CITY OF ALBUQUERQUE

RE: Master Tech Auto

Grading Plan Stamp Date: 2/4/20

Hydrology File: G14D093

GRADING AND DRAINAGE PLAN

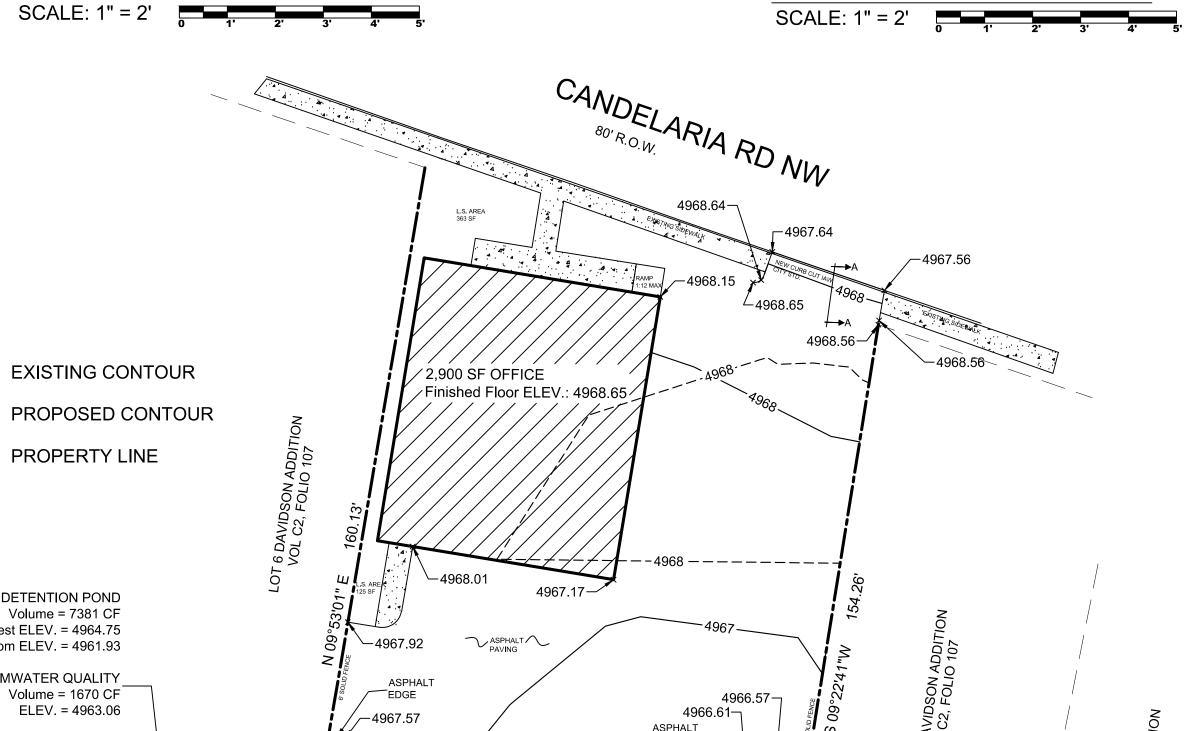
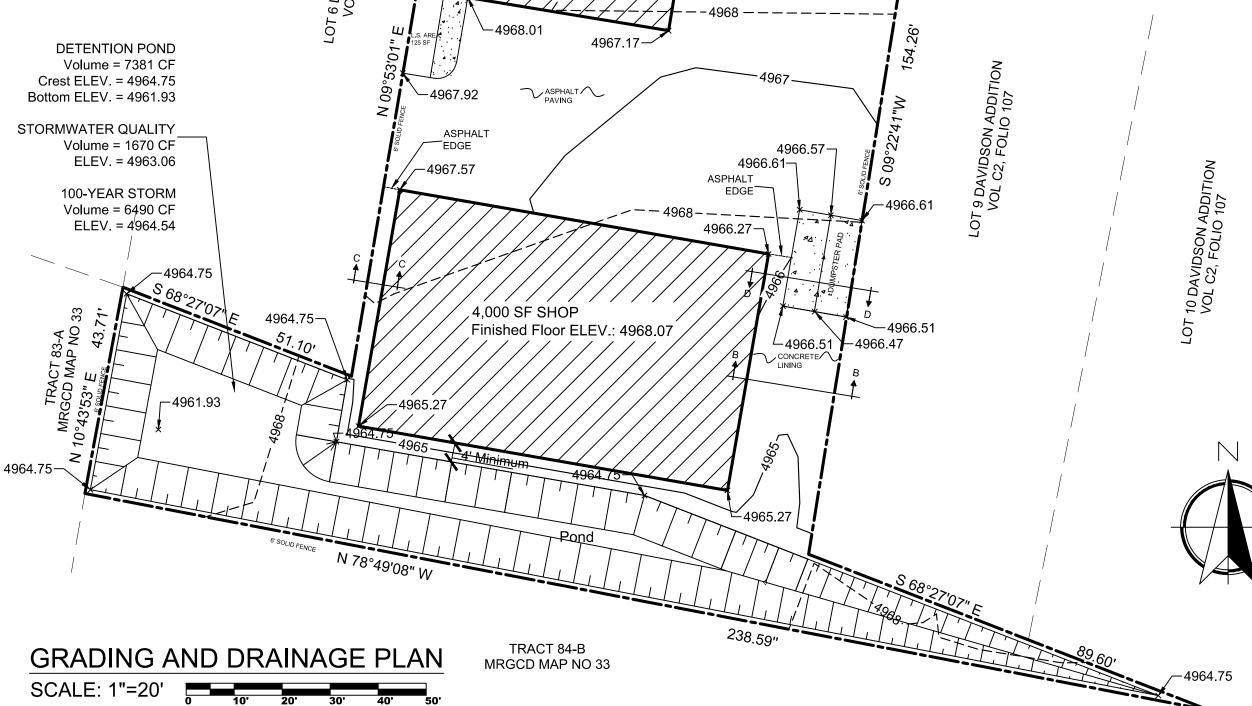
Based on the submittal received on 2/6/20, this project is approved for Building Permit.

Prior to Certificate of Occupancy (For Information):

1. Engineer's Certification, per the DPM Chapter 22.7: *Engineer's Certification Checklist For Non-Subdivision is required.*

2. A Bernalillo County Recorded <u>Drainage Covenant (No Public Easement)</u> is required for the stormwater control pond. The original notarized form, exhibit A (legible on 8.5x11 paper), and recording fee (\$25, payable to Bernalillo County) must be turned into DRC (4th, Plaza del Sol) for routing. Please contact Charlotte LaBadie (clabadie@cabq.gov, 924-3996) regarding the routing and recording process for covenants. The routing and recording process for covenants can take a month or longer; Hydrology recommends beginning this process as soon as possible as to not delay approval for certificate of occupancy.
